## BMW Motorrad USA Service Information Bulletin

### **\*\*Notice of Recall 09V-384\*\***

**Subject:** Checking/Replacing Multifunction Switch

**Model:** K 1300 S (K40/11) and K 1300 GT (K44/31)

Illustration: Checking the part number of the left multifunction switch (ease up the rubber grip)

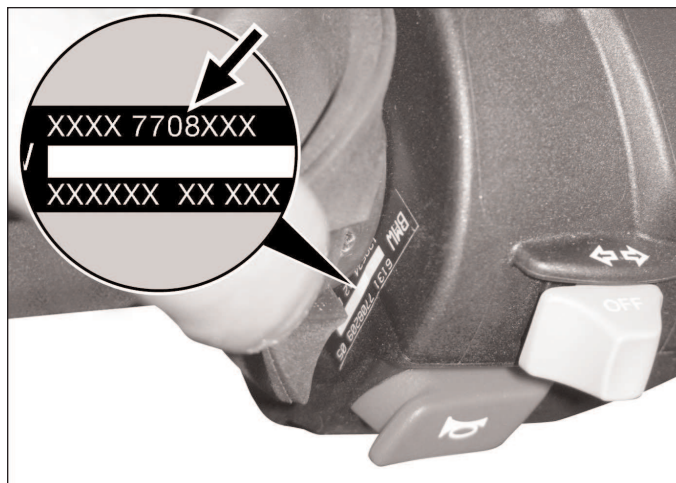
**Aftersales Solution:** Before proceeding with replacement, check the construction status of the left and right multifunction switches:  
Part No. 7 725 xxx = current status: Replacement is **not** necessary  
Part No. 7 708 xxx or 7 712 xxx = old status: Replacement **is** necessary

The part number is printed in the top part of the black label affixed to the side of the multifunction switch (see illustrations). Always check the switches on **both** sides.

**Replacement required:** Proceed in accordance with the instructions in the repair manual (RSD Repair & Service Data DVD). Refer to 00 60 204 Campaign, replace multifunction switch.

**Note:** Make sure that the left multifunction switch is not opened in the removal process. Switches with damaged part-number labels cannot be accepted for billing under warranty conditions.
